SIB 65 25 19

RECALL 19V-853: DRIVER'S FRONT AIR BAG (NADI) INFLATOR

This Service Information Bulletin (Revision 5) replaces SI B65 25 19 **dated April 2020**.

What's New (Specific text highlighted):

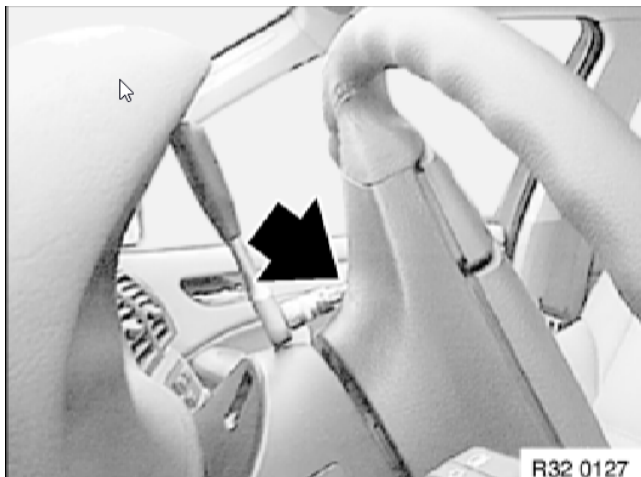
If the vehicle has a Category 1 air bag installed, then proceed with air bag gas generator replacement.

In the following cases the inflator/gas generator replacement should not be done and instead the complete air bag assembly must be replaced:

- Threaded bolts are damaged
- Threaded bolts are bent or corroded
- The generator cannot be removed from the air bag without excess force
- If the target tightening torque of the nuts cannot be achieved (5 Nm in a star pattern sequence)
- If there is a gap between the generator & air bag that is not closed-up when tightening the nuts
- If there is damage to the air bag cover that may impede deployment of the air bag

► Preparing the new gas generator

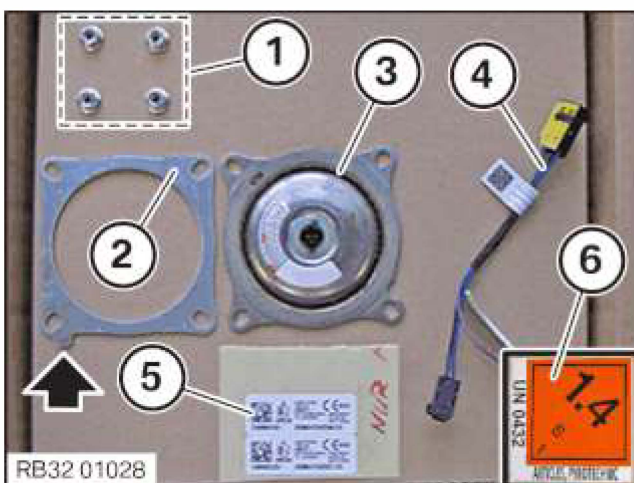
- Unpack the new nuts (1), reinforcement plate (2), new gas generator (3), cable (4) and sticker (5) and place it as shown.
- Make sure that the groove (arrow) of the reinforcement plate (2) is positioned correctly.
- USA only:
Dispose of the hazard sticker (6).

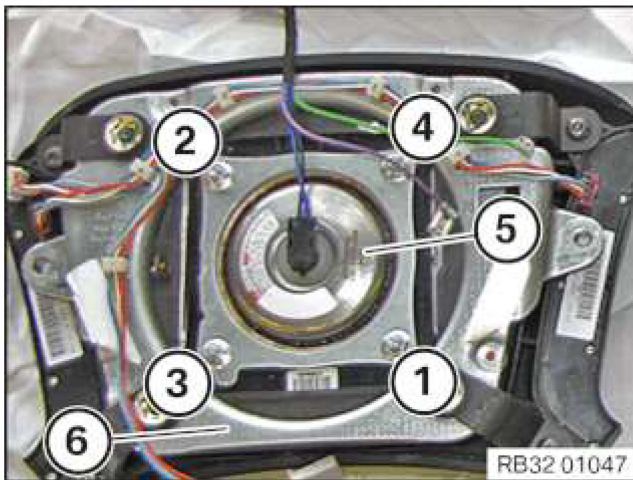
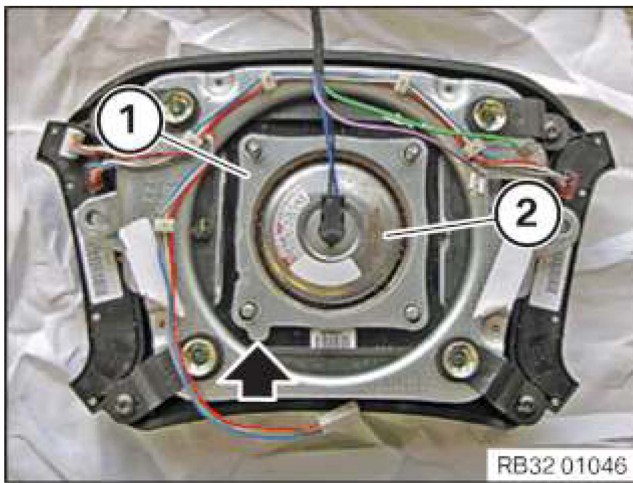
- Position the reinforcement plate (1) over the new gas generator (2).
- Make sure that the groove (arrow) of the reinforcement plate (1) is positioned correctly.

The groove (arrow) points downwards to the left.

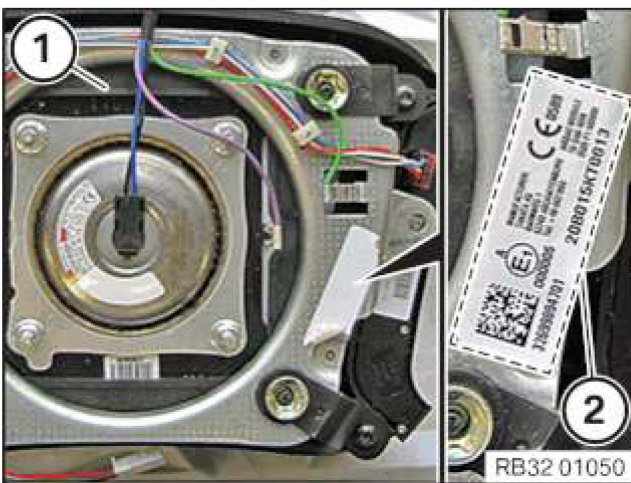
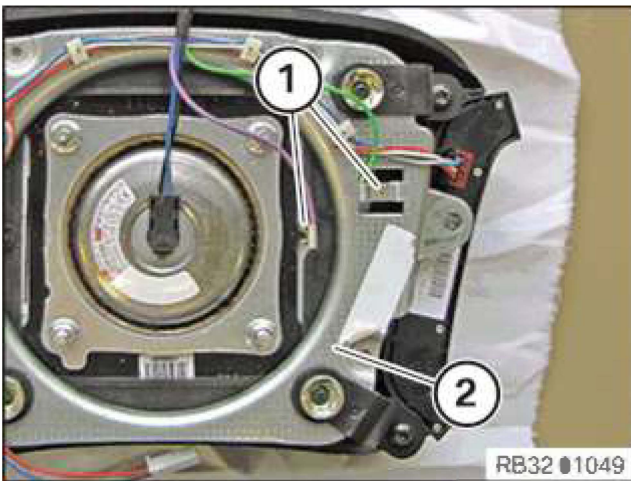
Visually inspect the gap (3) between the new gas generator (1), reinforcement plate (2) and airbag unit (4) on all four sides (5).

Visually inspect the gap (3) between the new gas generator (1), reinforcement plate (2) and airbag unit (4) on all four sides (5).

- **If the gap (3) is not OK:**

Release the screw connection and tighten again as described in the previous step. If the gap is still not OK, then cancel the repair. Install the new airbag unit in this case.
